Addendum No. 2
October 1, 2021

Project: **Harrisburg Middle School No. 3**
Harrisburg, South Dakota
Architecture Incorporated Project #2903

Architect: Architecture Incorporated

about contents: **FOOTING & FOUNDATION PLAN- AREA A- PLMB & HTG**

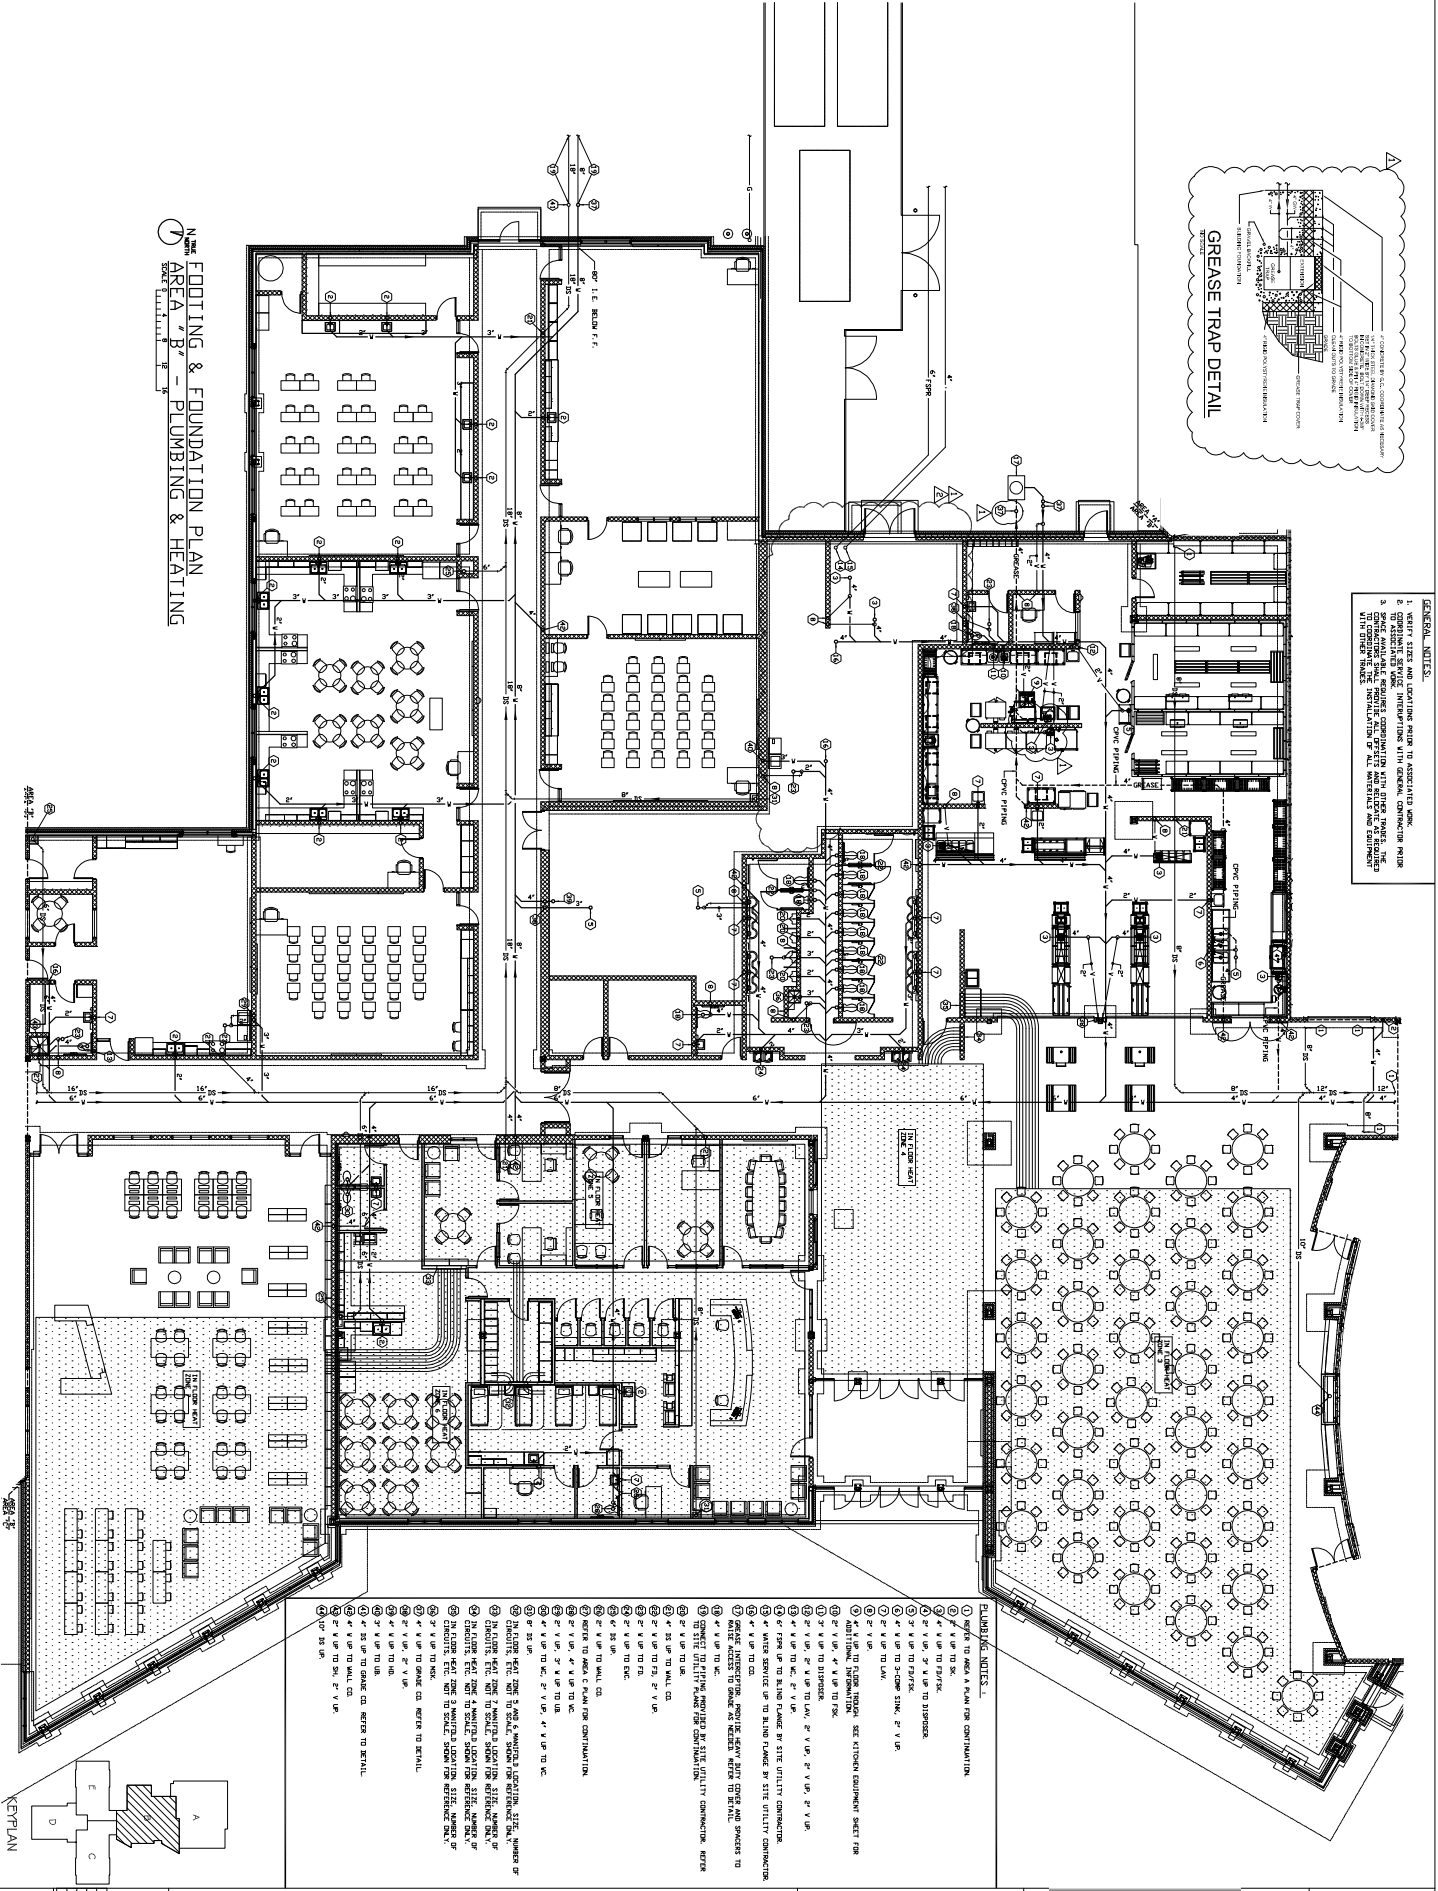
- a) Revise location of FD/FSK in “Stor A106”, including new waste and vent pipe routing. Refer to Revised Drawing Sheet, dated 10-1-21.

8.22

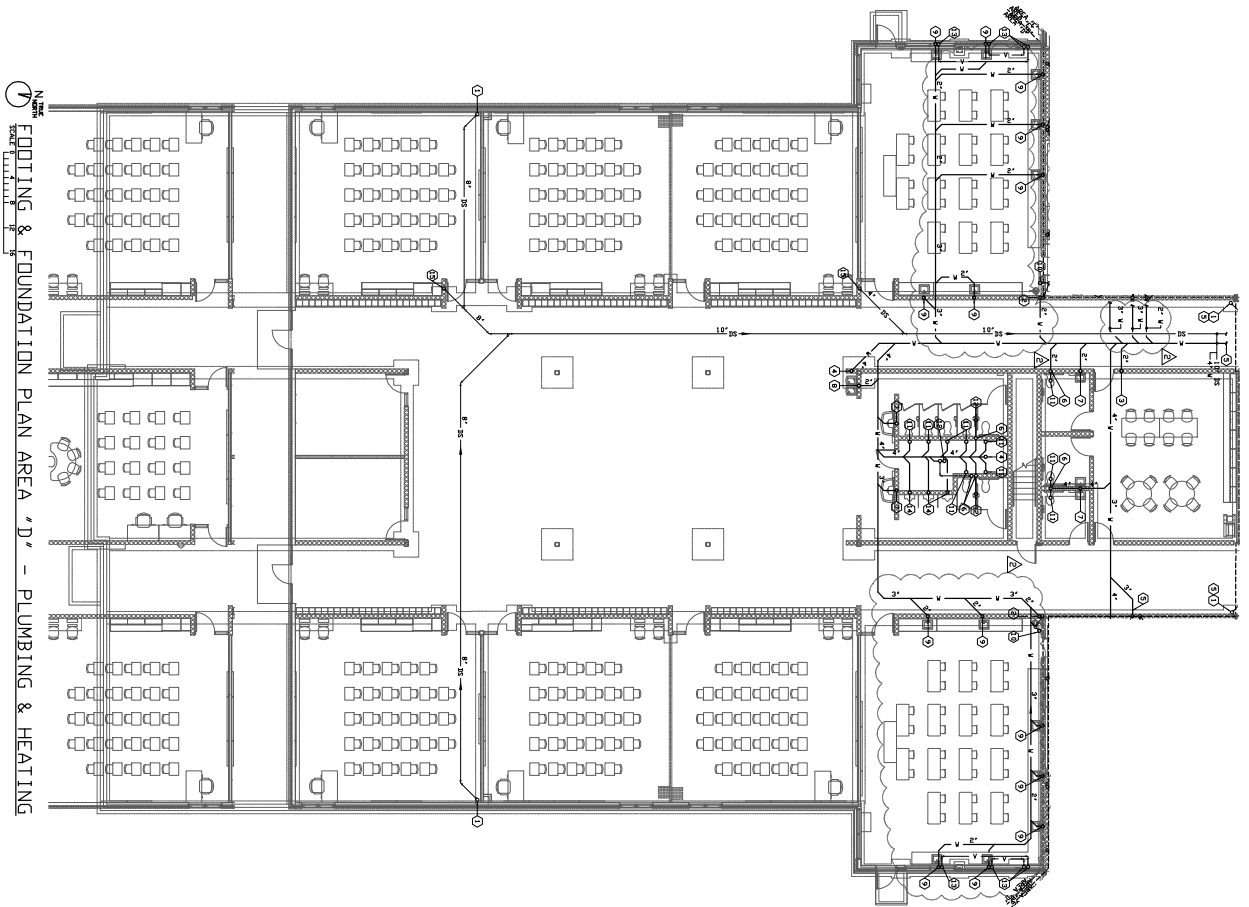
- a) Revise all acid waste/vent piping to regular waste/vent piping. Refer to Revised Drawing

8.23

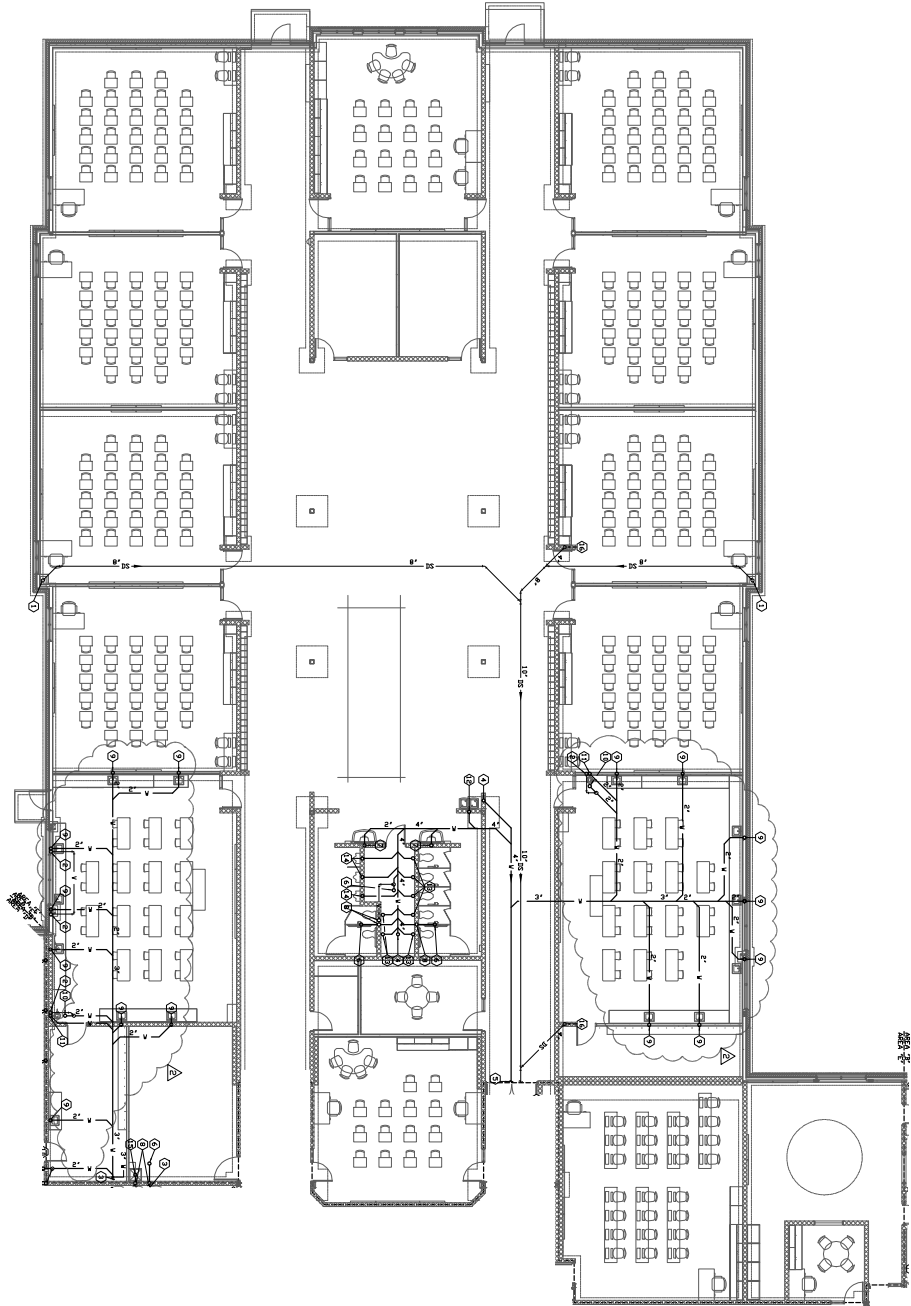
- 7) DRAWING SHEET 8.23 – FOOTING & FOUNDATION PLAN – AREA D – PLMB & HTG
 - a) Revise all acid waste/vent piping to regular waste/vent piping. Refer to Revised Drawing Sheet, dated 10-1-21.

8.27

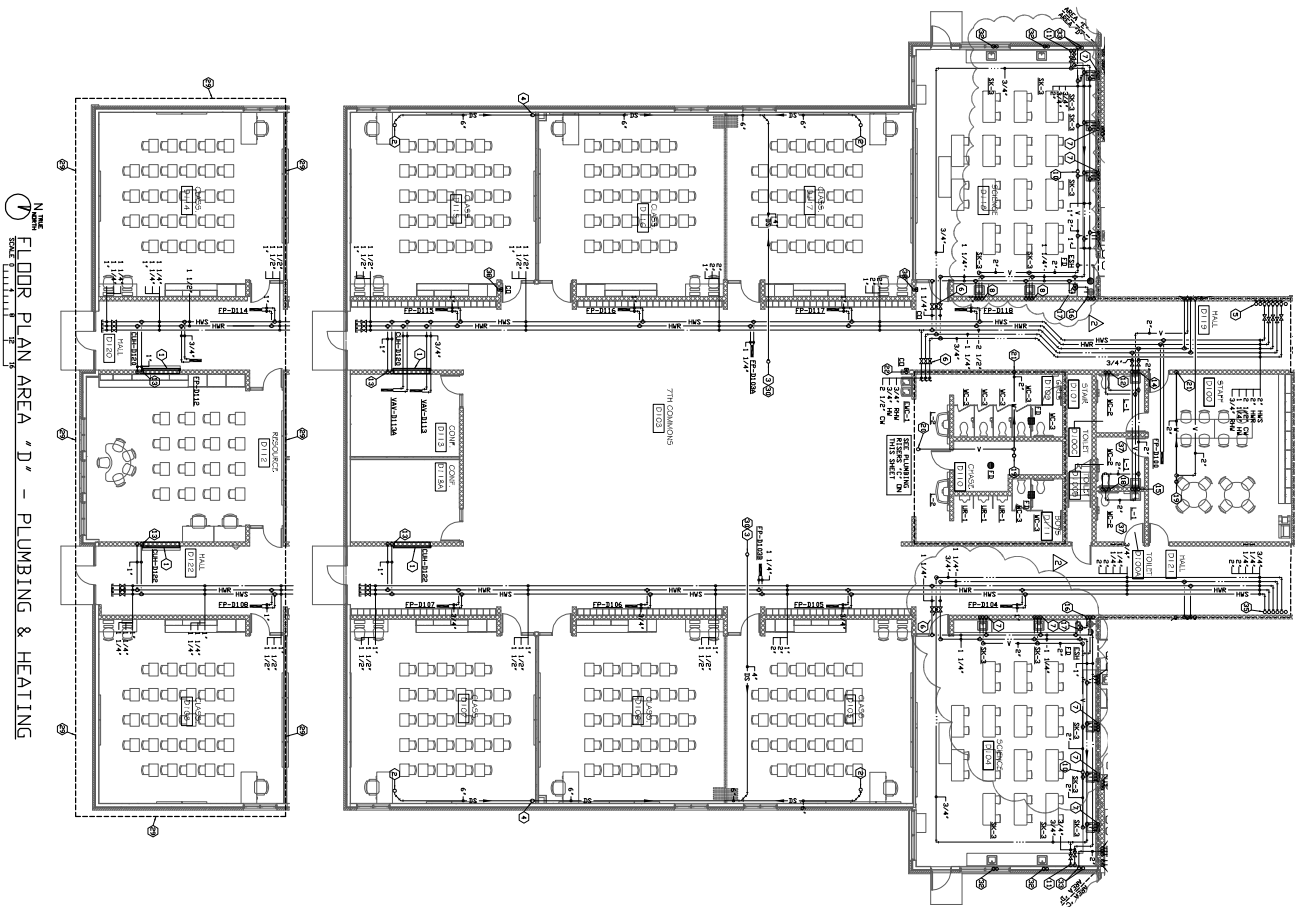
- 11) DRAWING SHEET 8.27 – FLOOR PLAN – AREA C – PLUMBING & HEATING
 - a) Revise all acid vent to regular vent piping. Refer to Revised Drawing Sheet, dated 10-1-21.

- b) Revise locations of VAV-C114 and VAV-C115, including corresponding pipe routing. Refer to Revised Drawing Sheet, dated 10-1-21.
- 12) DRAWING SHEET 8.28 – FLOOR PLAN – AREA D – PLUMBING & HEATING

8.28

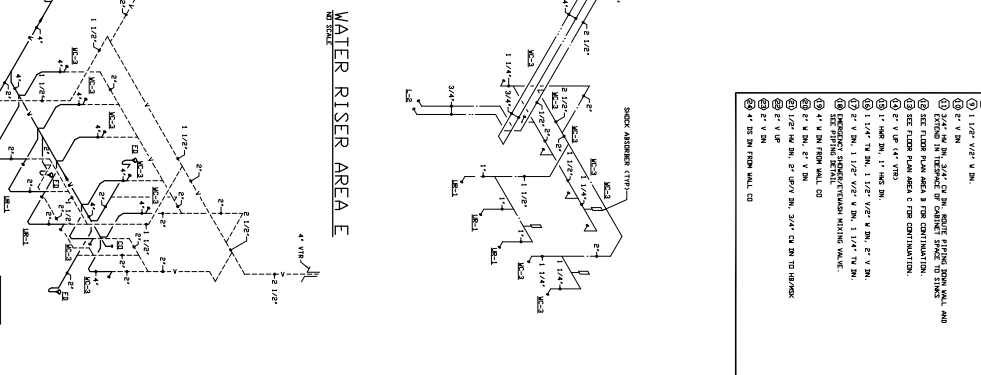
- a) Revise all acid vent to regular vent piping. Refer to Revised Drawing Sheet, dated 10-1-21.
- 13) DRAWING SHEET 8.29 – FLOOR PLAN – AREA E – PLUMBING & HEATING

ENLARGED PLAN - AREA A PENTHOUSE - PLUMBING & HEATING

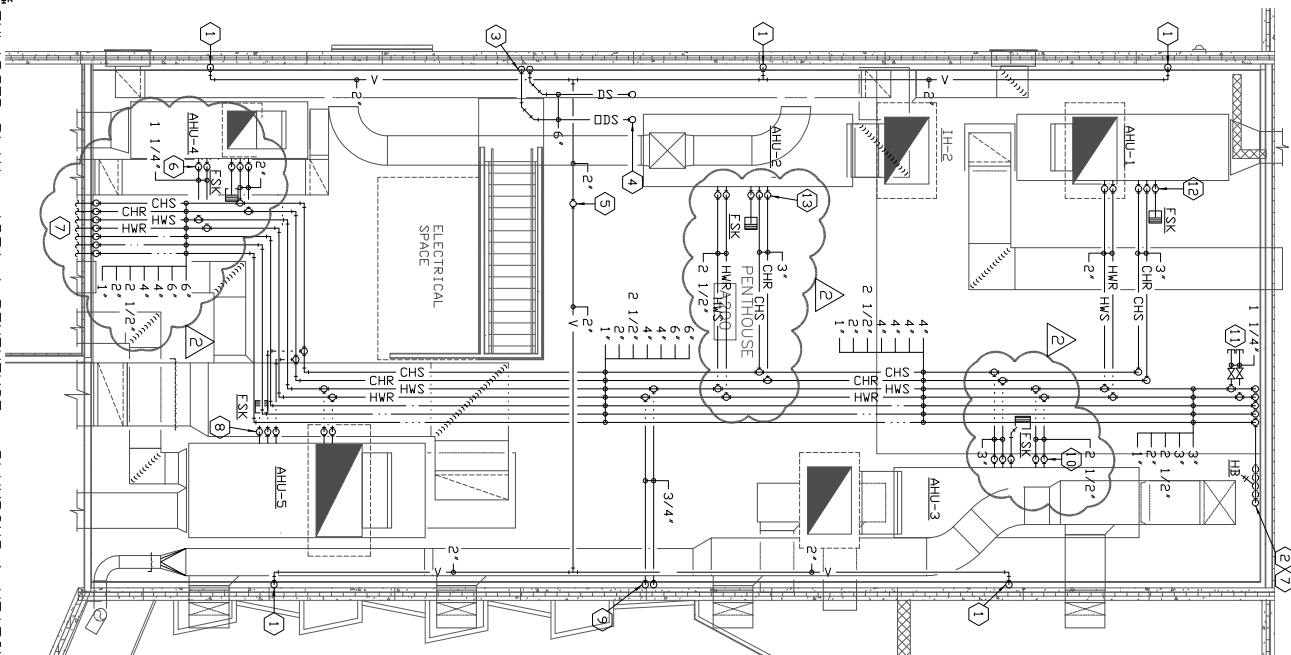
- 14) DRAWING SHEET 8.30 – PENTHOUSE PLAN – AREA A – PLMB & HTG
- a) AHU-2, AHU-3, and AHU-4 revised to have the heating coil downstream of the cooling coil. Refer to Revised Drawing Sheet, dated 10-1-21.
